STAFF REPORT

Executive Summary									
Hearing Body:	Millcreek Township Planning Commission								
Meeting Date and Time:	Wed. December 12, 2012	04:00 PM	File No:	2	8	0	3	8	
Applicant Name:	Nathan Anderson	Request:	Conditional Use						
Description:	24 unit apartment building								
Location:	1431 E. 3900 S.								
Zone:	R-M Residential Multi-Family	Any Zoning Conditions?	Yes <input type="checkbox"/>	No <input checked="" type="checkbox"/>					
Community Council Rec:	Approval with Conditions								
Staff Recommendation:	Approval with Conditions								
Planner:	Spencer G. Sanders

1 LANDSCAPE PLAN
SCALE 1/16" = 1'-0"

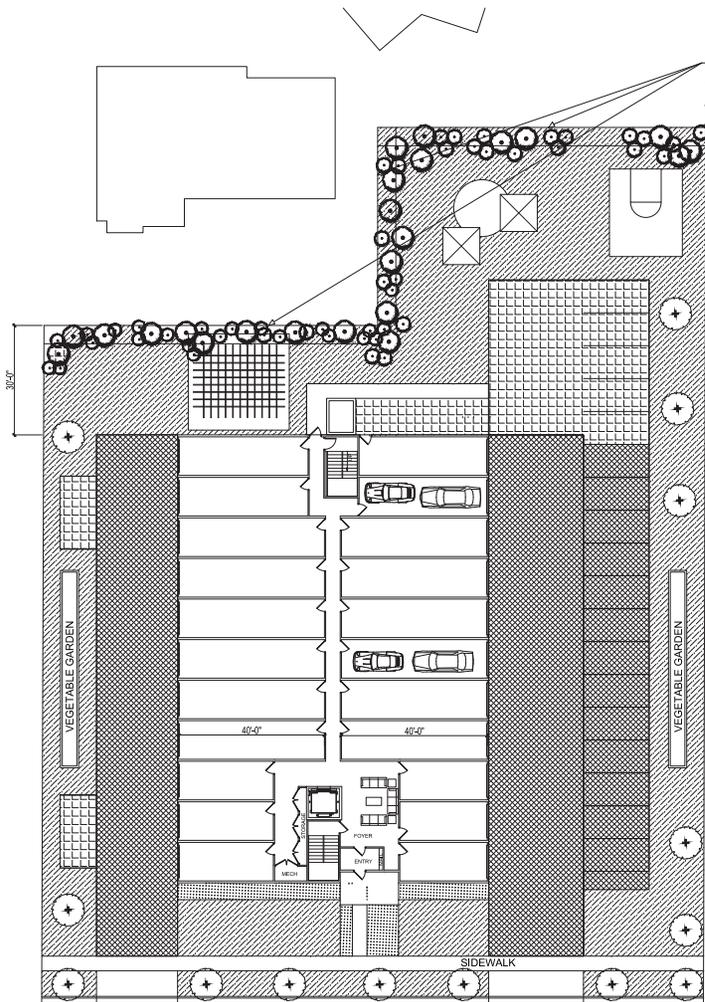
Details: None of the facilities are fully designed and detailed, so it is difficult to confirm their acceptability under the policy. Additional detail will be need to confirm compliance with this development standard. It is important to note here that the current location of the garden beds will likely need to change. They should be relocated to the more consolidated recreation area to the rear of the building so that the required landscaping, including 1 tree for every 25 lineal feet can be met along the side property lines.

2.2.6 Landscaping - The preliminary landscape plan submitted does not provide sufficient information to confirm that the final plan will comply with County landscape ordinance. A number of details will need to be provided and the landscape plan refined. For example, there will likely need to be more trees along the site property lines as well as in the front setback behind the sidewalk. Nevertheless, the current plan does outline the applicant's idea behind providing a fairly solid landscape buffer along the south property line. The applicant has said that the variety and quantity of trees along the rear property line are intended to create a green visual buffer for the residents of the neighborhood to the north. A mixture of

evergreen and deciduous trees are proposed to be used that will get quite tall and create a year-round screen. The applicant has indicated that this screen will help block his proposed building from view by the northern residents. A revised preliminary landscape plan will need to be provided that reflects this intent as well as reflect the requirements of the County's Water-wise Landscape Ordinance. It will also important to help soften the building from the street with adequate landscape. While the current plans do not fully satisfy preliminary landscape plan requirements. It does appear that there will be enough area provided to achieve compliance.

- 2)The building setback shall be 30 feet from the rear property line as outlined in the proposal and that a significant and densely planted screen of trees and shrubs be installed to reduce the visual impact and possible impact on privacy on the adjacent residents.
